ORIGINATION FORM

Proposed Revisions to a Standard Plans Index
(Please provide all information — Incomplete forms will be returned)

Index Number: 700-110
Sheet Number (s): 1
Index Title: Mounting Exit Number Panels To Signs

LAST REVISION	DESCRIPTION:		FY 2023-24 STANDARD PLANS	MOUNTING EXIT NUMBER PANELS TO SIGNS	INDEX 700-110	SHEET 1 of 1
11/01/22	11/01/23

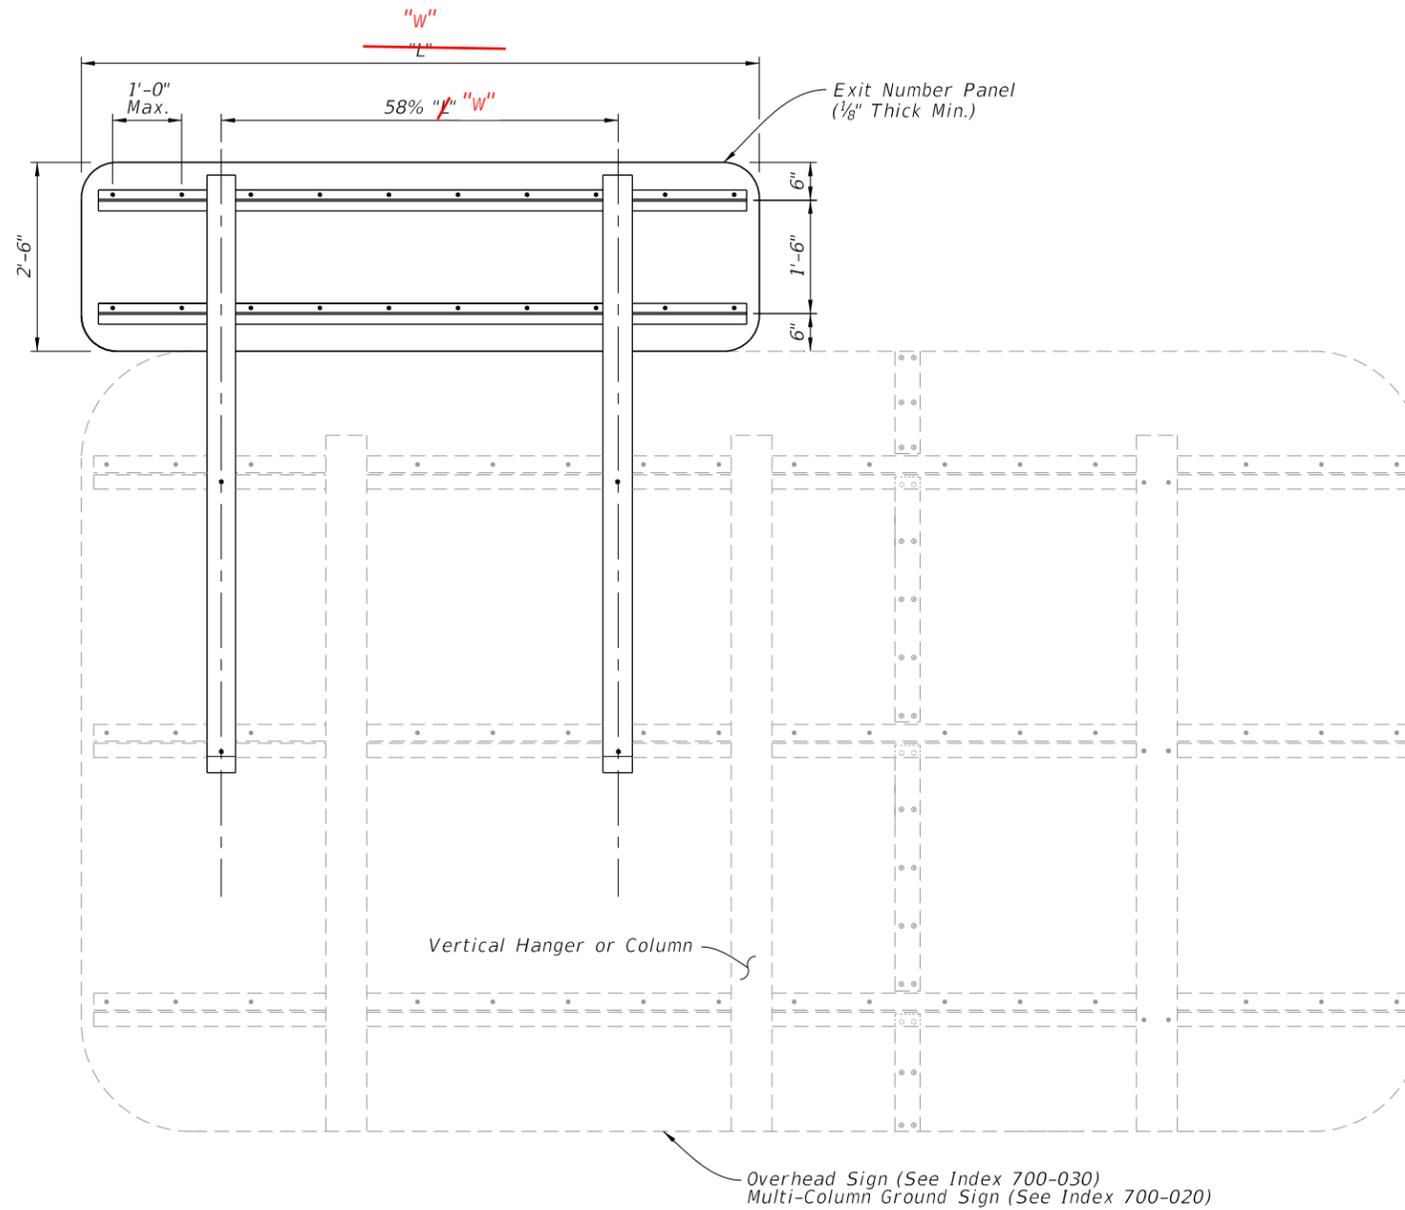
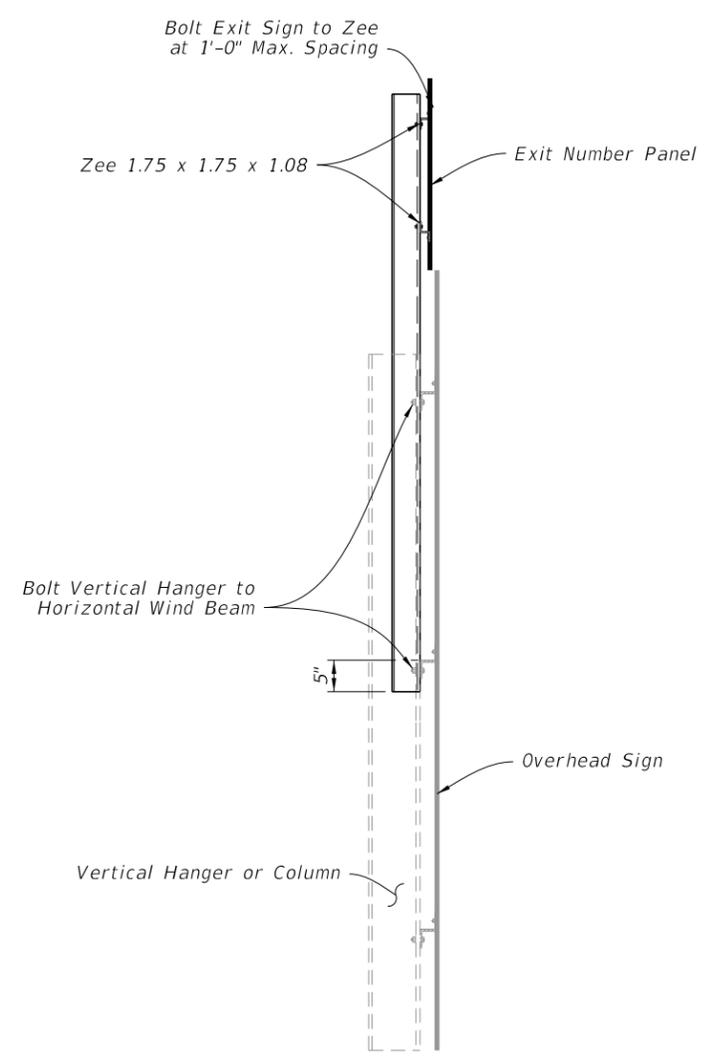
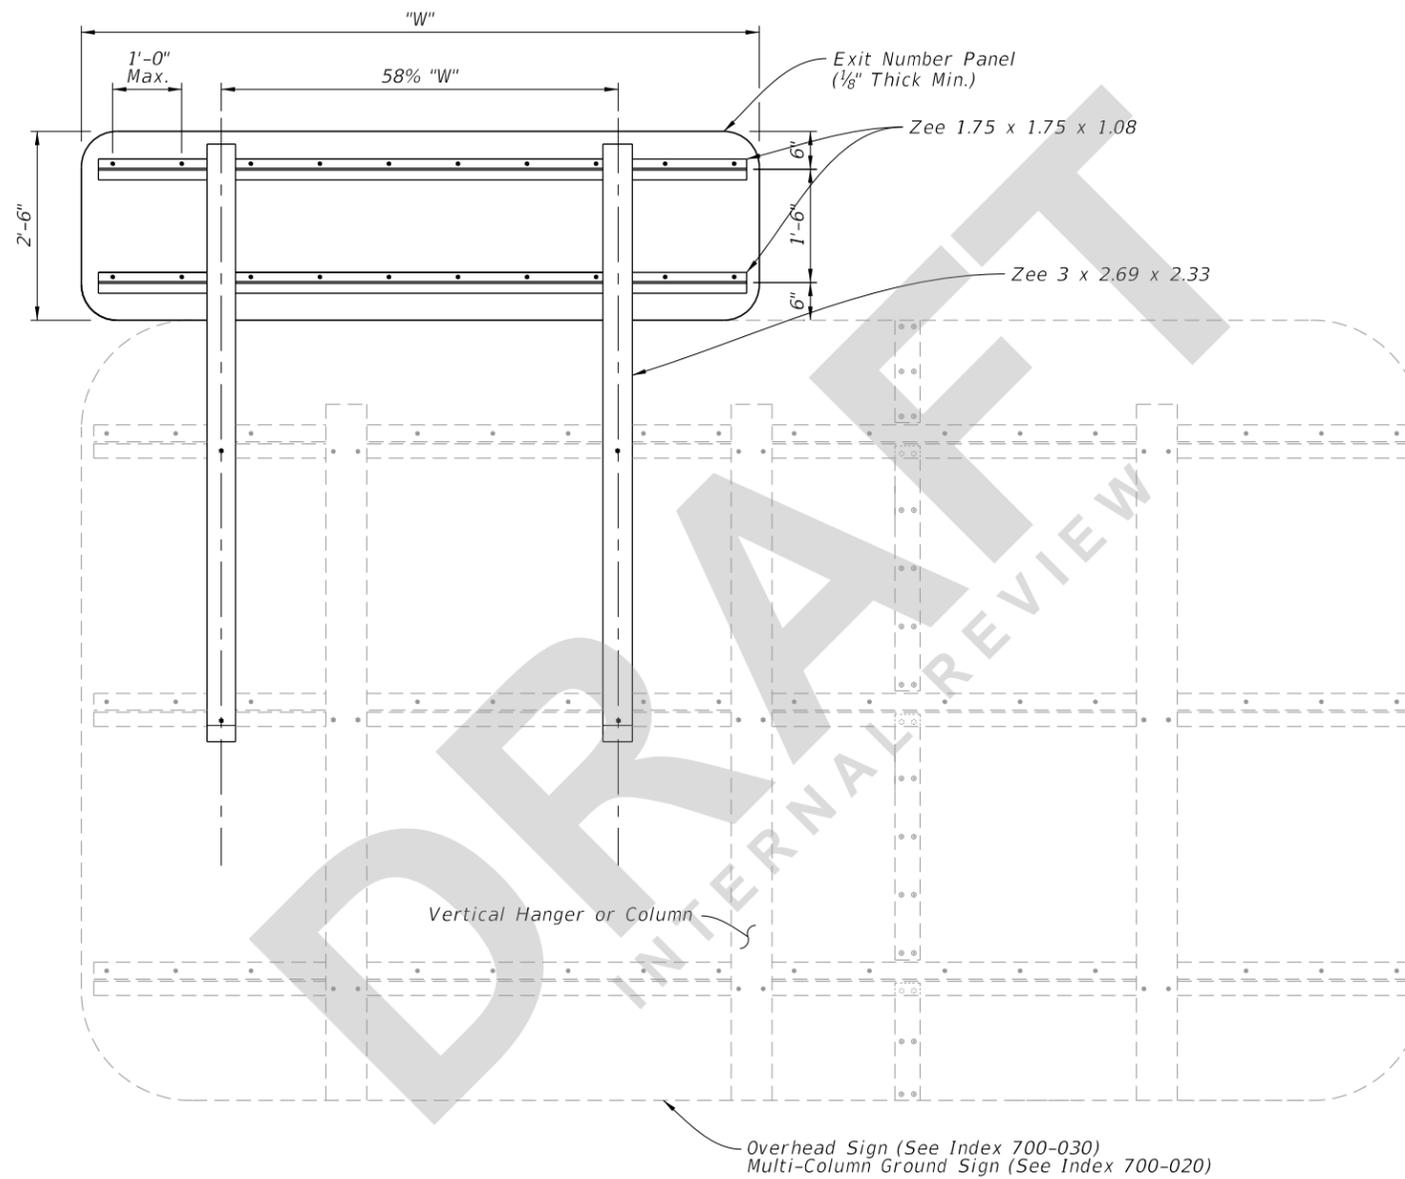
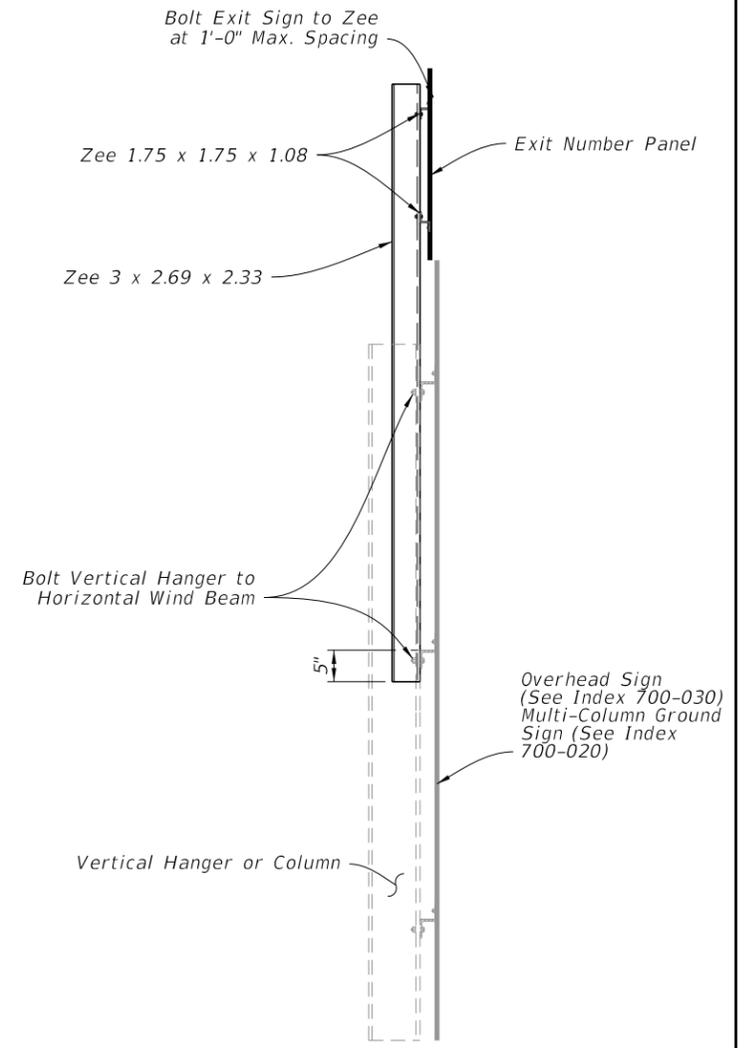
Changed all reference of length to width to keep consistent with MUTCD

The change is to be consistent with how the MUTCD dimensions signs. Section 700 and 995 will also need to be updated to be consistent with MUTCD.

1. Meet the requirements of Specification 700.
2. Work with Indexes 700-020 and 700-030.
3. Fabrication:
See sign layout sheet for dimension "W" and sign face details in the Plans.
4. For right exits, install the Exit Numbering Panel to the top right side of the Highway Sign.
5. For left exits, install the Exit Numbering Panel to the top left side of the Highway Sign.
